June 18, 2012

RE: Envirosafe Services of Ohio, Inc.
 Ohio EPA ID No. 03-48-0092
 USEPA ID No. OHD 045 243 706
 Permit Modification Request No. 074:
 Revision of TLL Compliance Date at SWMU 6

SWMU 6 EQUIPOTENTIAL MAP

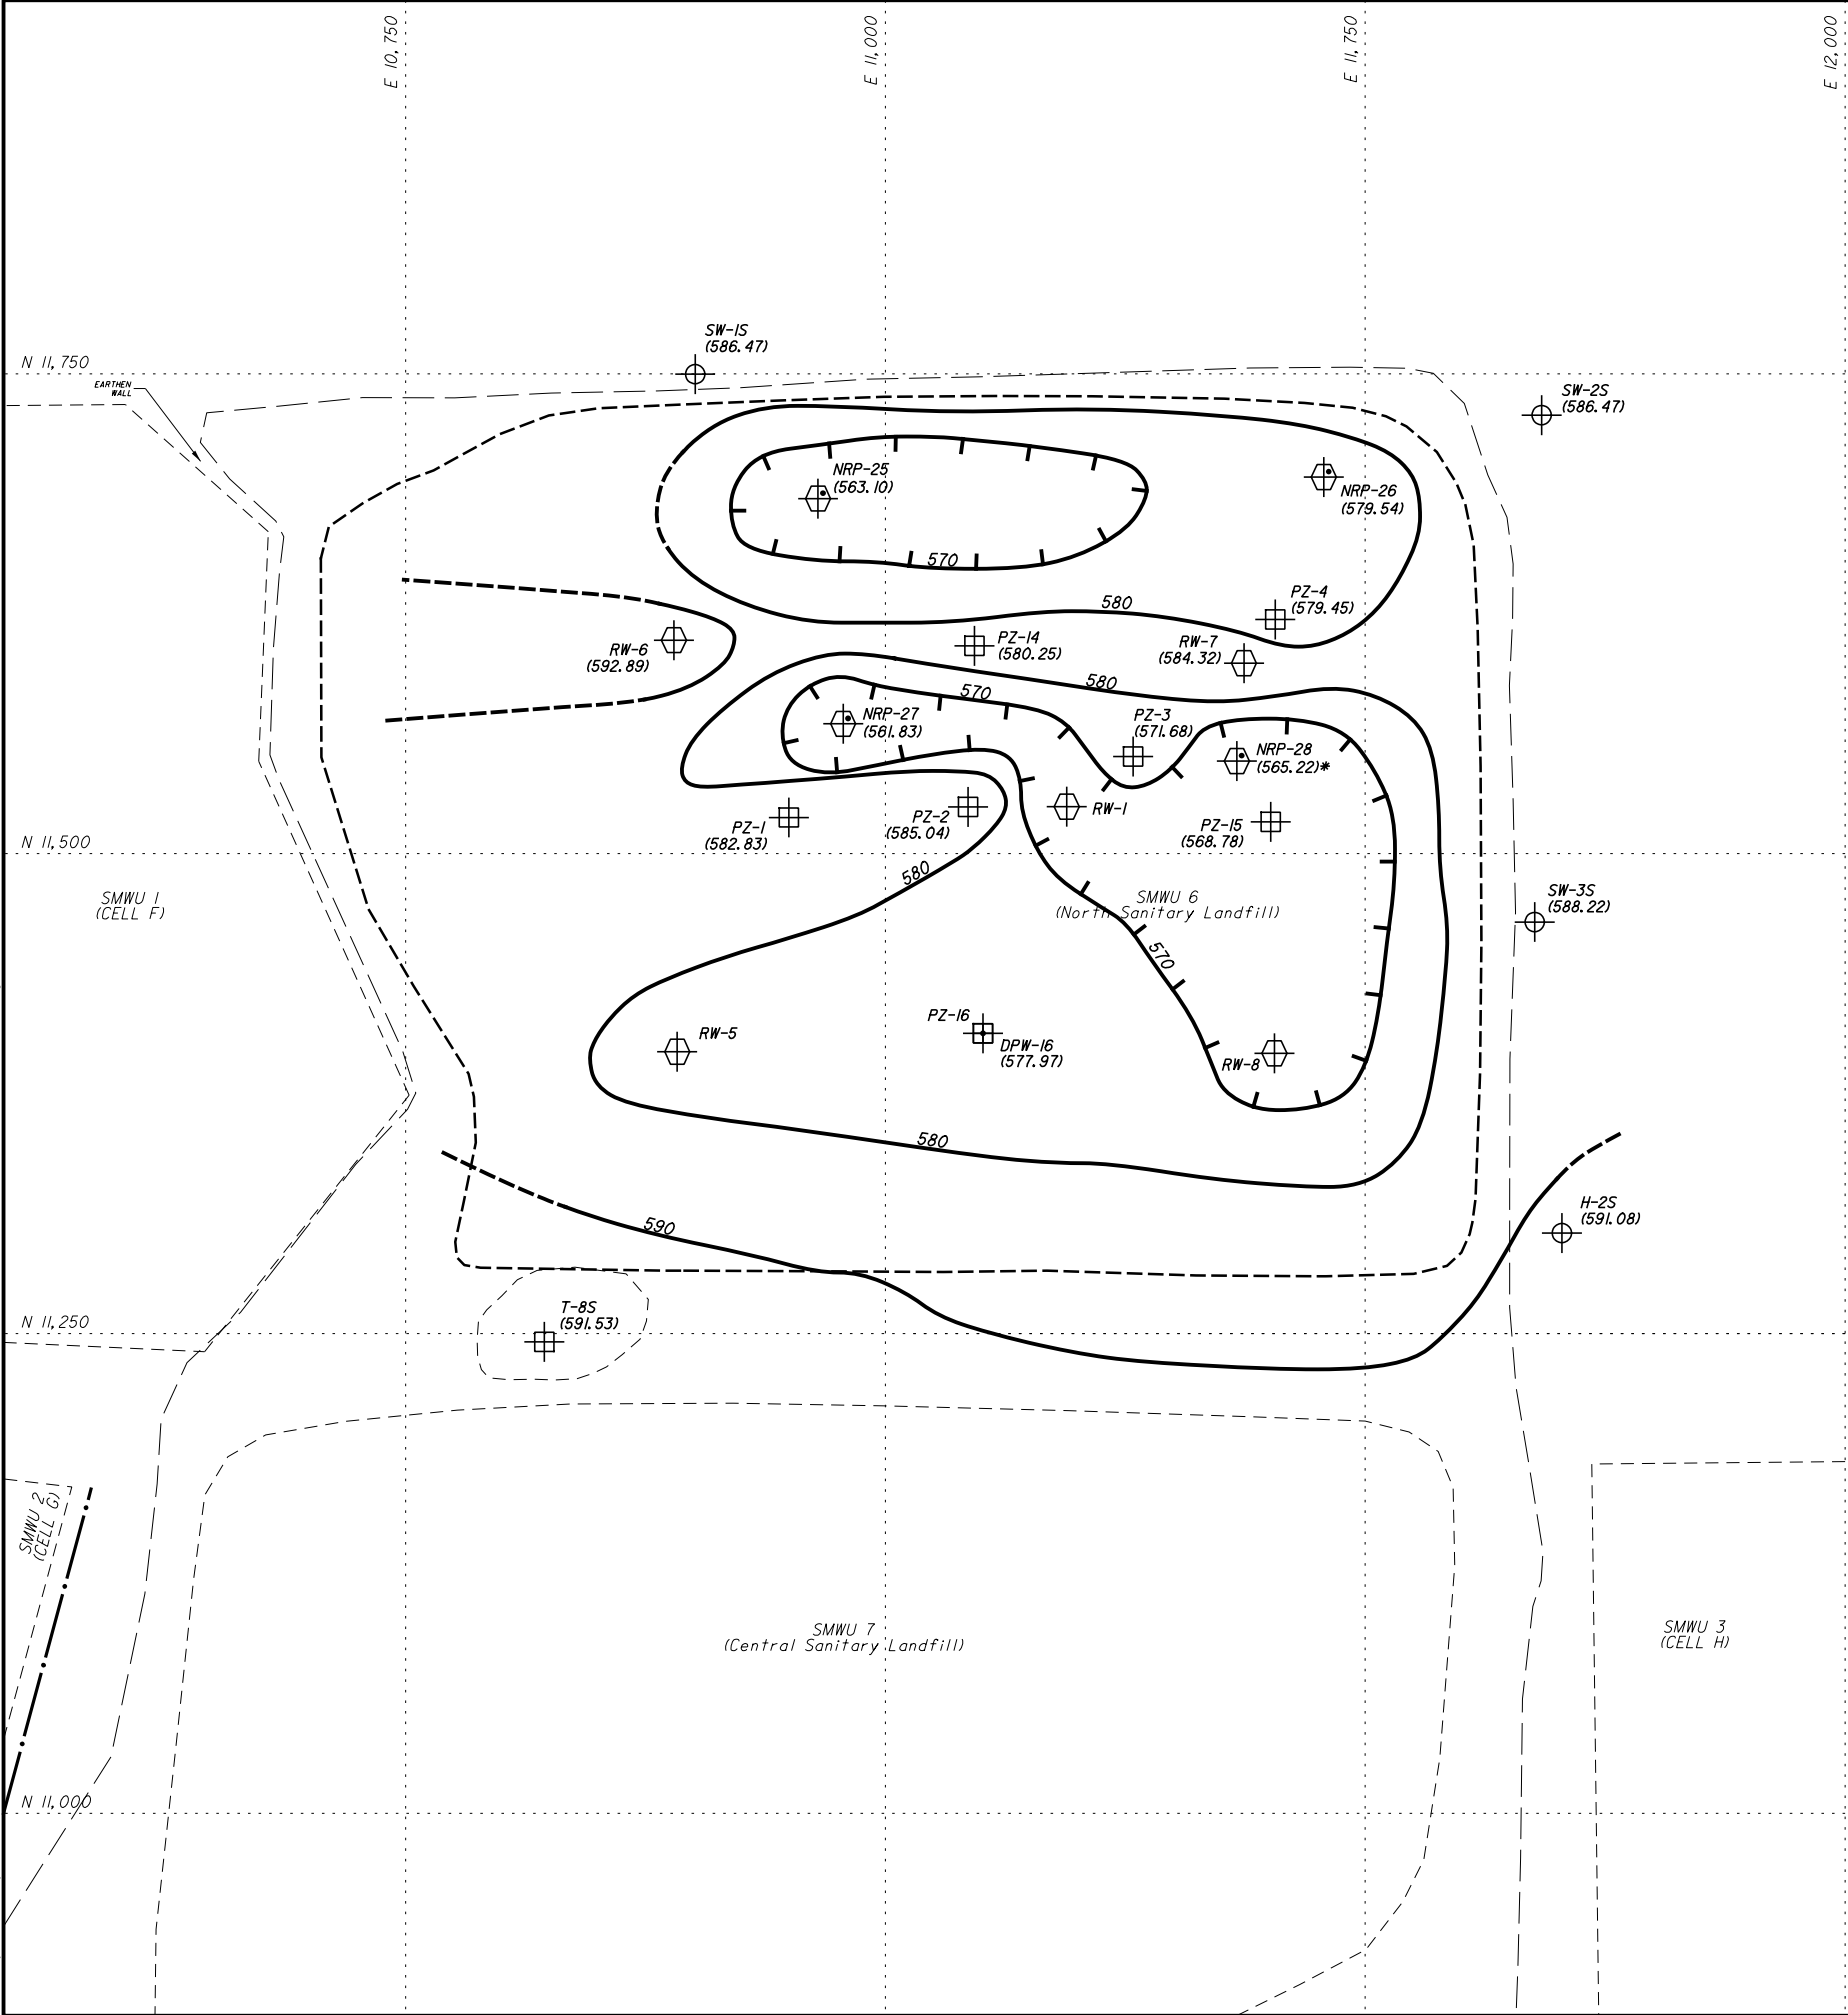
ESOI is requesting a 12 month extension of the SWMU 6 TLL milestone date to July 1, 2013. This will enable ESOI to complete the expedited corrective measures related to storm water management and evaluate approximately 6 months of response to the action. It will also provide ESOI with time to test different level probes, compare level reading, and evaluate the accuracy of the historical data. ESOI is also requesting that the following piezometers be excluded from TLL calculations as they are not representative of the overall leachate level in SWMU 6: PZ-1 and PZ-2 (and PZ-4 and PZ-14 which are already listed as shallow piezometers in the approved OMPM Plan). The enclosed drawing from the 2011 Annual Report clearly shows that these wells are not located in a formation that is strongly affected by pumping of adjacent wells. While the elevations have lowered over time and provide an indication of dewatering, the downward trend has significantly slowed indicating that the leachate level is now below a less permeable wall. While the wall will drain slowly, it is not representative of the leachate level across the unit.

Historical aerial photographs presented in the RFI also indicate that they may be located in an access ramp, roadway or trench sidewall.

- (c) WMU 6: No later than July 1, 2013, the permittee will ensure that the average of the leachate head level measurements from the deep interior piezometers, as identified in Table 1.0 of the OMPM Plan, is maintained below a Target Leachate Level of 566.9 ft. MSL and that the WMU is effectively dewatered in the vicinities of the shallow interior piezometers as identified in Table 1.0 of the OMPM Plan.
